November 7, 2018

Mr. Jan Bovier
U.S. Department of Energy Office of River Protection
P.O. Box 450, MSIN H6-60
Richland, WA 99354
Email: WMACDRAFTWIR@rl.gov

RE: NRDC/Hanford Challenge and Columbia Riverkeeper Comments on *Draft Waste Incidental to Reprocessing Evaluation for Closure of Waste Management Area C at the Hanford Site, Washington*

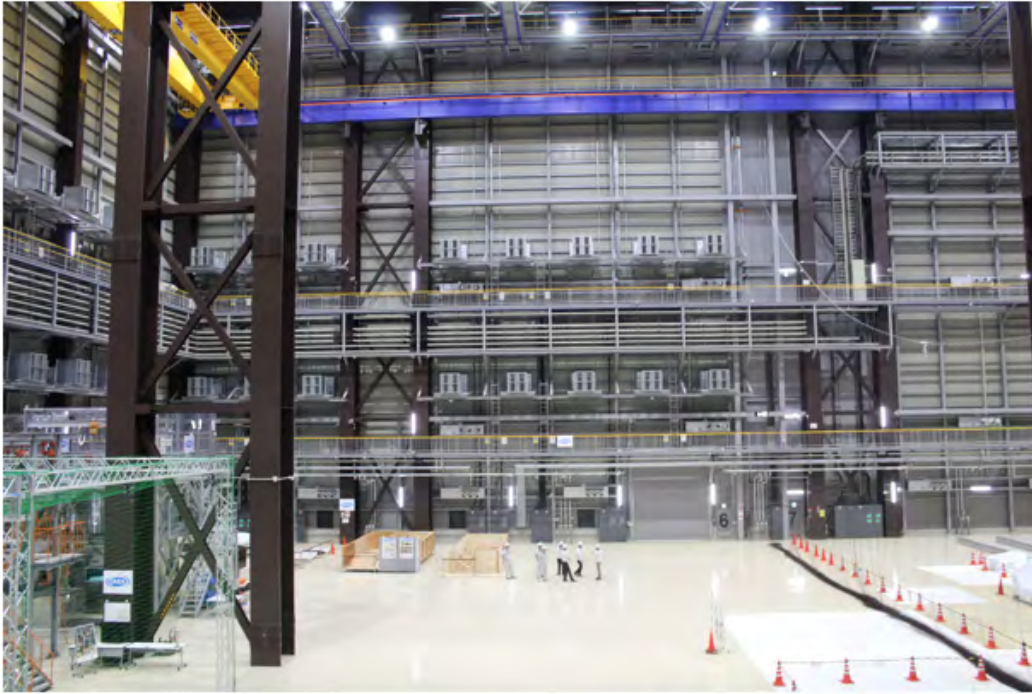
The failure to properly define the limits to technology means that HLW would be abandoned in place without employing additional technologies that could retrieve refractory solids in the WMA C tanks. Failure to remove the remaining HLW in the tanks makes it far more difficult to remove the tanks themselves. Tank recovery and removal is likely to be a key initial step to removing leaked HLW in the vadose zone below the tanks. Adding grout of course, only increases the difficulty of retrieval, potentially making HLW remediation from the vadose zone impossible.

During the two year campaign to remove HLW from tank C-101 the solids removal rate twice rose from less than 0.1 % solids removed in slurry to 0.5 % removed or greater. (Higher solids percentages mean that HLW is still being retrieved at a significant pace.) This is significant because, had DOE ended the retrieval after the first drop to 0.1% solids removal, then all of the remaining material removed after that point would have been abandoned instead of retrieved. When the solids removal rate dropped below 0.1% for a third time, DOE simply ended the procedure and declared that the technology limit had been reached.

In experimental design, this behavior is called p-value hacking, meaning stopping data collection when one gets the result they were hoping for. (P-value hacking, when detected by reviewers, normally results in rejection of a scientific study.) DOE failed to collect data on whether this third “minimum” solids removal test was truly the rock bottom, or just another drop preceding a return to significant solids removal (a drop and rise that had already occurred twice for this tank).

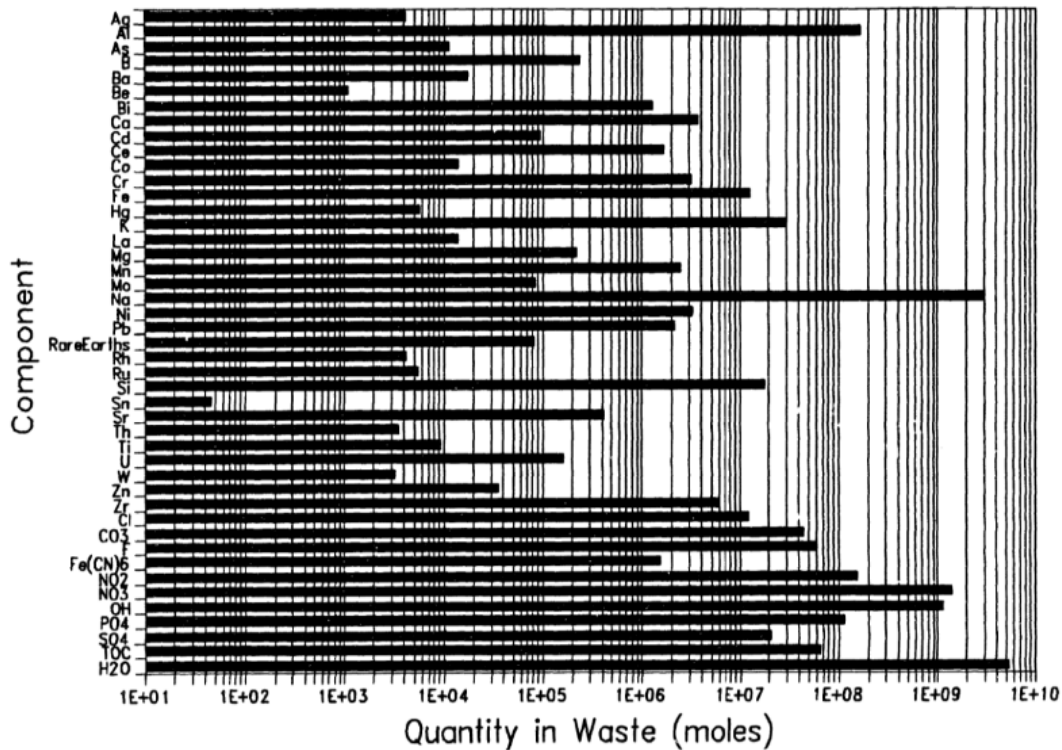
At Hanford, nonradioactive iron compounds in tank solids provide an important safety buffer against exceeding the CSL. However in some tanks, such as C-101, waste streams were disposed that had iron to plutonium-239 ratios of less than 5:1 (iron:plutonium-239). Differential loss of iron compounds would significantly impact the safety factor below the criticality safety limit for this waste solid in C-101.

On average in Hanford waste tanks, there are higher concentrations (on a molar basis) on plutonium in the solids versus the supernatant liquids in tanks. Tank C-110 has nearly a 100X greater plutonium concentration in solids compared to liquids. It is the solids left behind that will account for much of the abandoned residuals in tank wastes, meaning leaving a 4% residual of solids potentially leaves much more than 4% of a tank’s plutonium in shallow burial. Tank liquids will be readily removed; most of these have plutonium concentrations between 10^{-6} and 10^{-9} molar. Tanks solids are most likely to be in the residual; these are 10^{-4} to 10^{-6} molar, with more than two orders of magnitude greater plutonium concentration.
